STAFF ANALYSIS

Case No.: SLUP-18-22039/ 2018-1592 **Agenda #:** N.4

Request: To request a Special Land Use Permit to allow a Wendy’s restaurant with a drive-through lane in the C-1 (Local Commercial) District in accordance with Section 27-4.1 Use Table and Section 27-4.2.23 of the DeKalb County Code.

EXHIBIT 201 BY CIVIL ENGINEER. ALL RIGHTS RESERVED.

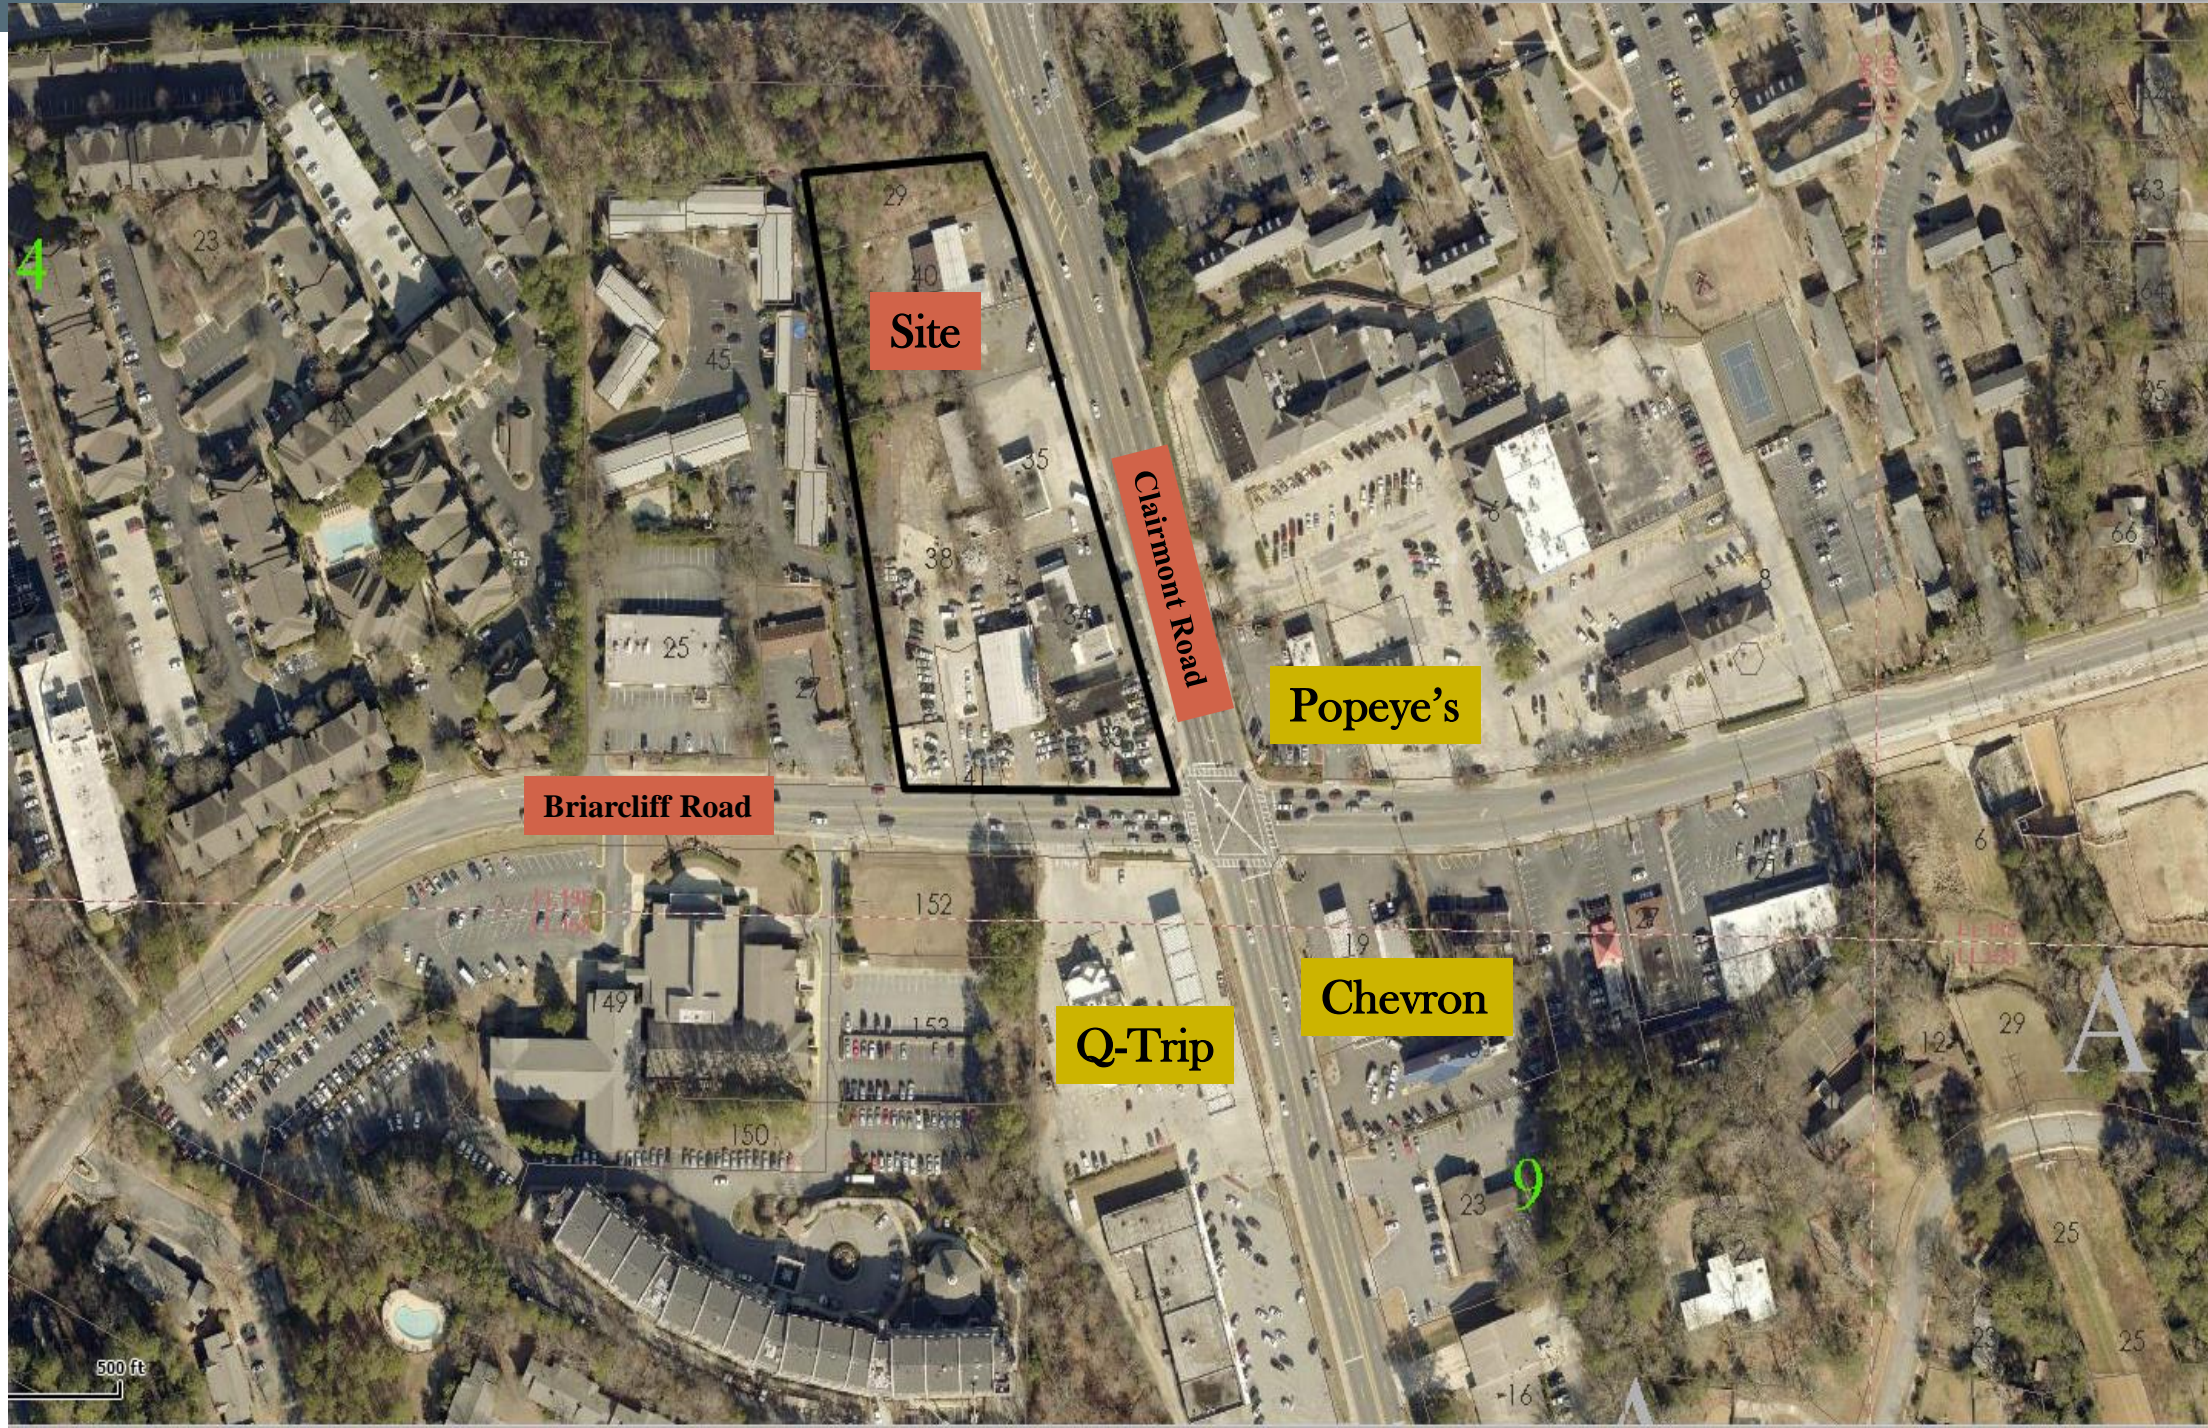
The site proposes 31 on-site parking spaces for Wendy's customers. A 10-foot wide landscape strip is depicted along the Clairmont Road property frontage. Staff notes the submitted site plan depicts an encroachment into the required transitional buffers adjacent to residential zoned properties. Also, the Landscape Plan exhibit fails to show planting requirements for the transitional buffer. A pedestrian connection from the property to the sidewalk is shown along Clairmont Road which Staff shall include in the recommended conditions. The SLUP request to allow a drive-through restaurant on the site is compatible with other commercial uses in the area. At the northeast intersection of Briarcliff Road and Clairmont Road is a Popeye's restaurant with a drive-through lane.

PARKING LOT LANDSCAPING Article 5.4.4.D	10% total parking lot in landscape space. 1 tree per 8 parking spaces. 1 tree required.	None shown on site plan.	Site must show compliance during permitting process.

Speaker box from proposed drive-through is 60 feet from residential zoned property.

Per the submitted site plan, speaker boxes are oriented towards the proposed RaceTrac convenience store building on Tract 1 of the overall development.

Site plan depicts a bypass lane with a width of 18 feet in compliance with above standard.

The submitted site plan depicts an encroachment (access drive) within required transitional buffer along adjacent residential zoned property lines.

1. A restaurant with a drive-through lane as depicted on the site plan stamped received by the Department of Planning and Sustainability on January 30, 2018. Said site plan is conceptual and is subject to compliance to C-1 (Local Commercial) development standards unless variances are obtained from appropriate regulatory authorities.

3. Provide inter-parcel access to all adjacent parcels subject to the approval of the Department of Public Works, Transportation Division.
4. Provide a pedestrian connection from the Wendy's restaurant to the public sidewalk.

7. Provide parking lot lighting on site.
8. The approval of this SLUP application by the Board of Commissioners has no bearing on the requirements for other regulatory approvals under the Zoning Board of Appeals, or other entity.
